**PLANNED UNIT DEVELOPMENT  
STAFF REPORT****Date: December 15, 2011****DEVELOPMENT NAME**

DAA Acquisition of Alabama

**LOCATION**3030 McVay Drive North  
(East side of McVay Drive North, 810' ± South of  
Government Boulevard, and extending to the South side of  
Macmae Drive)**CITY COUNCIL  
DISTRICT**

SITE PLAN

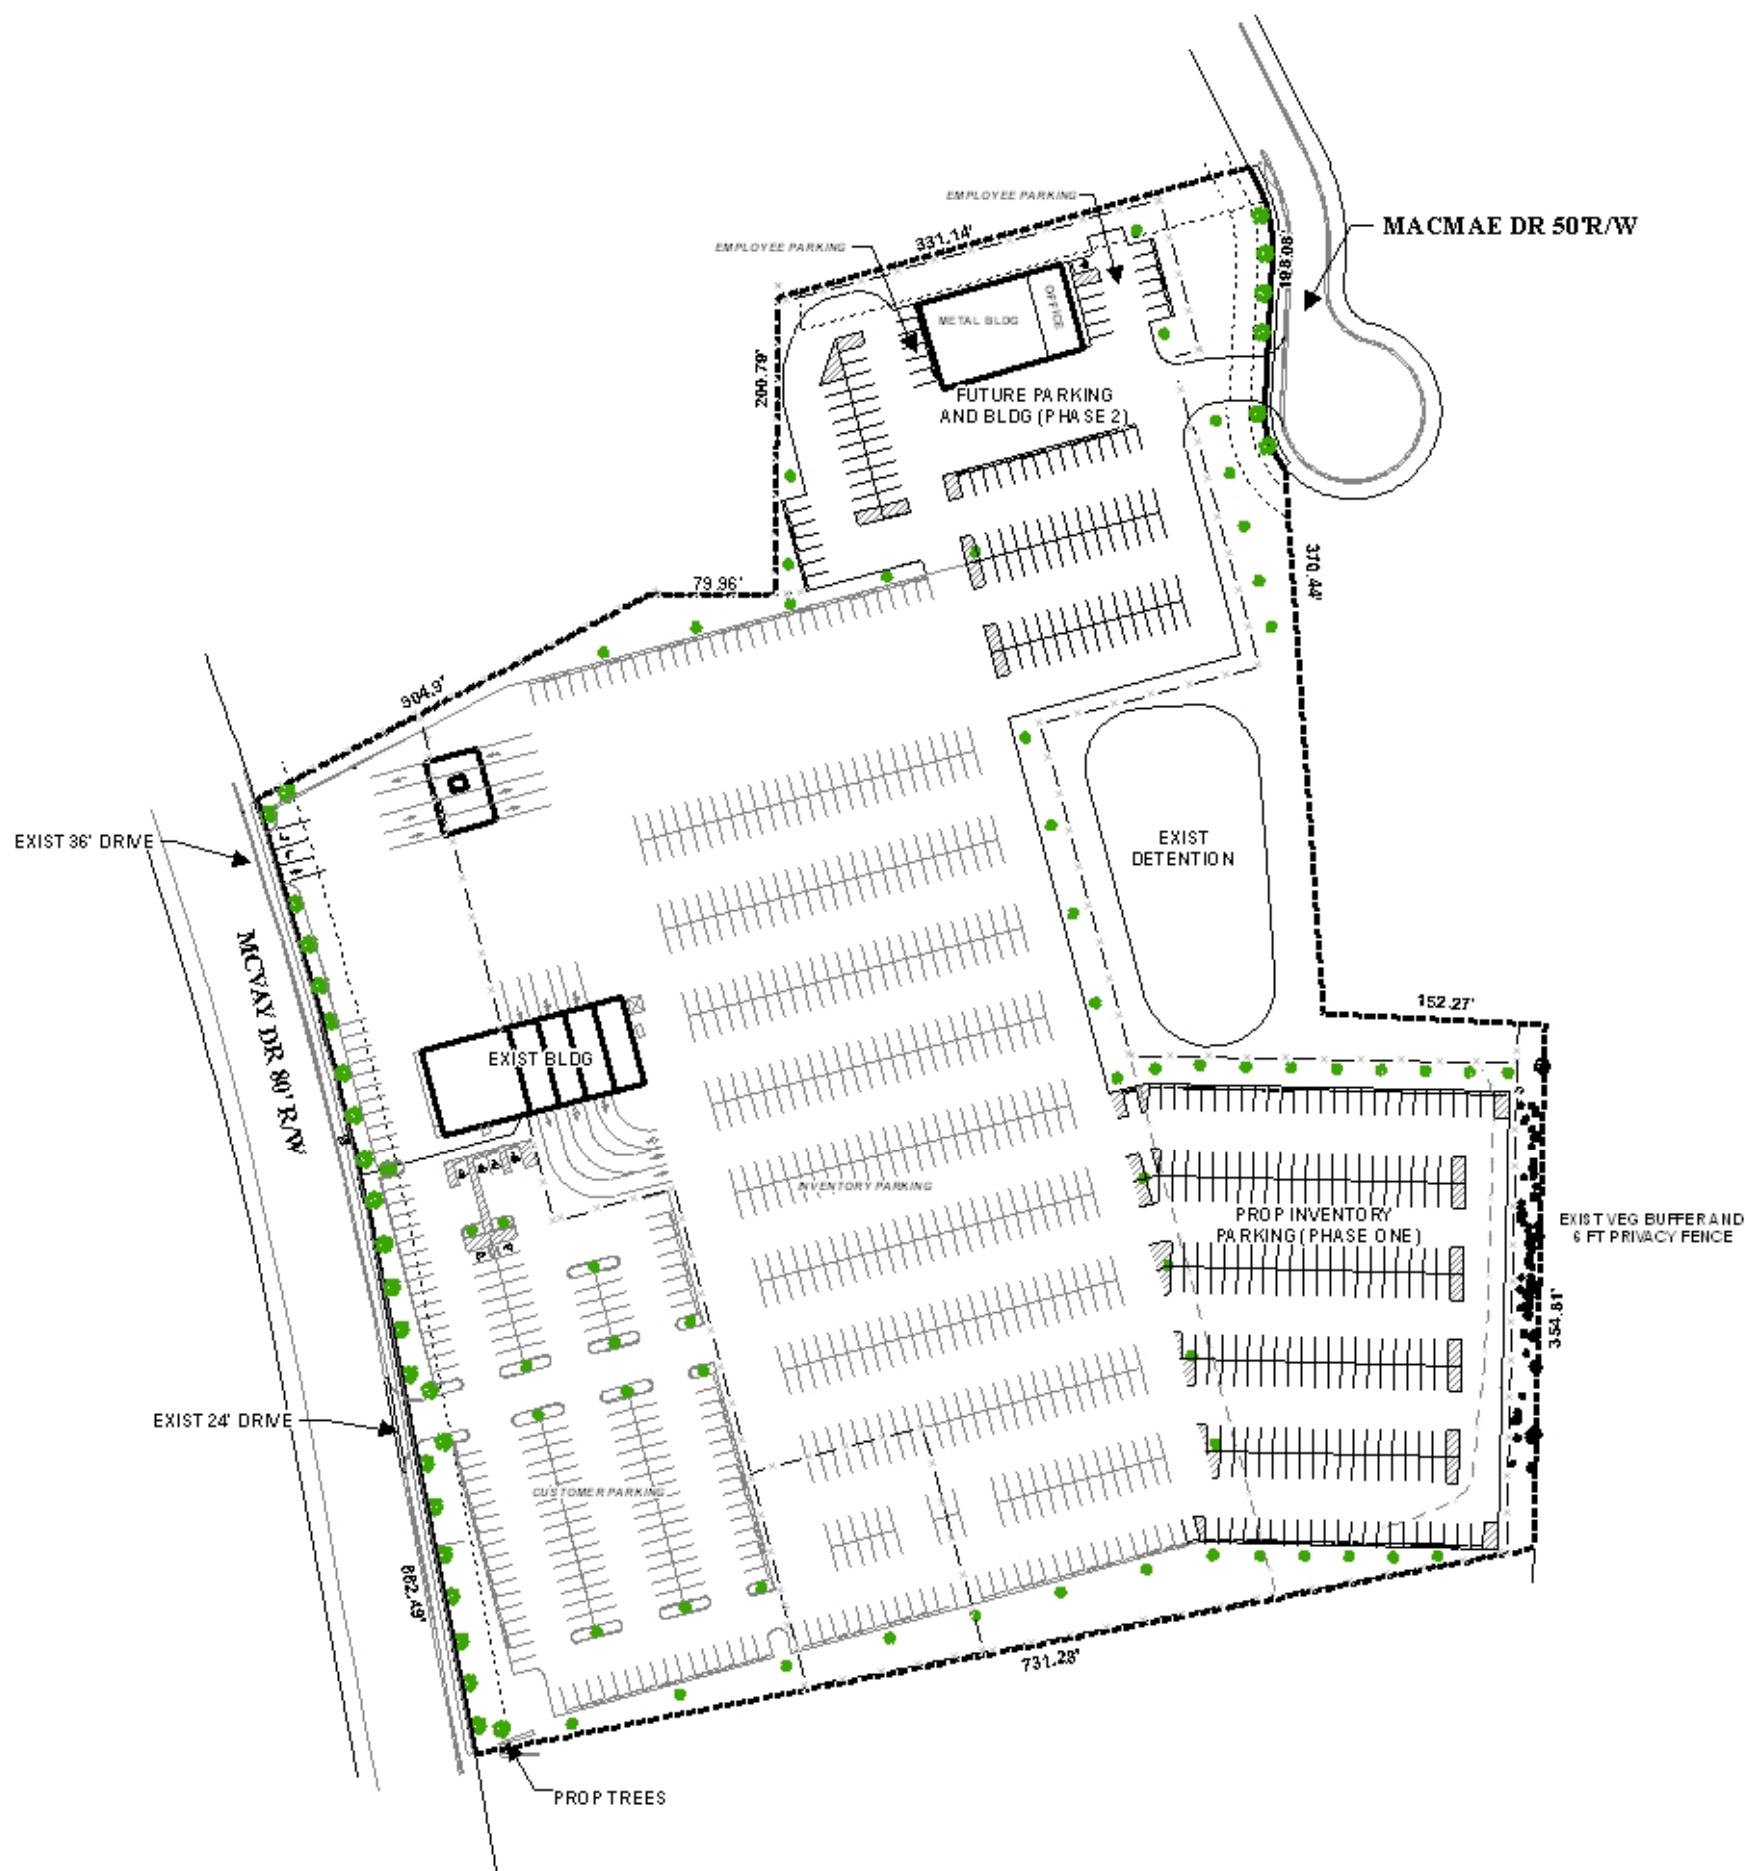
Driveway number, size, location, and design to be approved by Traffic Engineering and conform to AASHTO standards. Driveway on Macmae

Drive should be limited to 24' wide. Radii for Macmae Drive driveway are not illustrated on the site plan. A 20' radius is typical for passenger cars and a 30' radius is desirable for large trucks.

The site plan depicts the proposed improvements. The parking spaces, maneuvering areas, and buildings are compliant with the Zoning Ordinance. The site plan does not depict some required

bumper stops. Where curbing is not provided along the edge of pavement, bumper stops must be provided.

Regarding landscaping and tree plantings on the site, the site is required to have 71,874 square feet of total landscaping (12% of the total site area of 598,950 square feet), with 43,124 square feet (60%) of that total located between the building wall and the right-of-way line. The site plan depicts total landscaping at 130,931 square feet, or 21.8 % of the site, and 29,310 square feet of front landscaping, or only 68% of the required amount.

The applicant did not provide any justification for the need for the reduced front landscaping. The site is extensively developed already, and the proposed development will essentially max-out the site for development. Phase Two is the portion of the development which will lead to non-compliance. It is possible to modify the site plan and achieve compliance with frontage landscaping requirements. While the modifications would eliminate some parking spaces, the site is more than adequate to achieve the parking required by the Ordinance. Non-compliance with the front landscaping requirements may indicate overdevelopment of the site. As such, the applicant should redesign the Phase Two portion of the site to indicate compliance. There is nothing peculiar to the site that would justify a reduction in front landscaping requirements.

Note: Frontage Landscaping deficient by 13,814 SF

- 1) revision of the site plan to depict either curbing or bumper stops for all parking spaces along the edge of the paved area; and

- 2) revision of the site plan to depict full compliance with the frontage landscaping requirements, specifically in Phase Two.
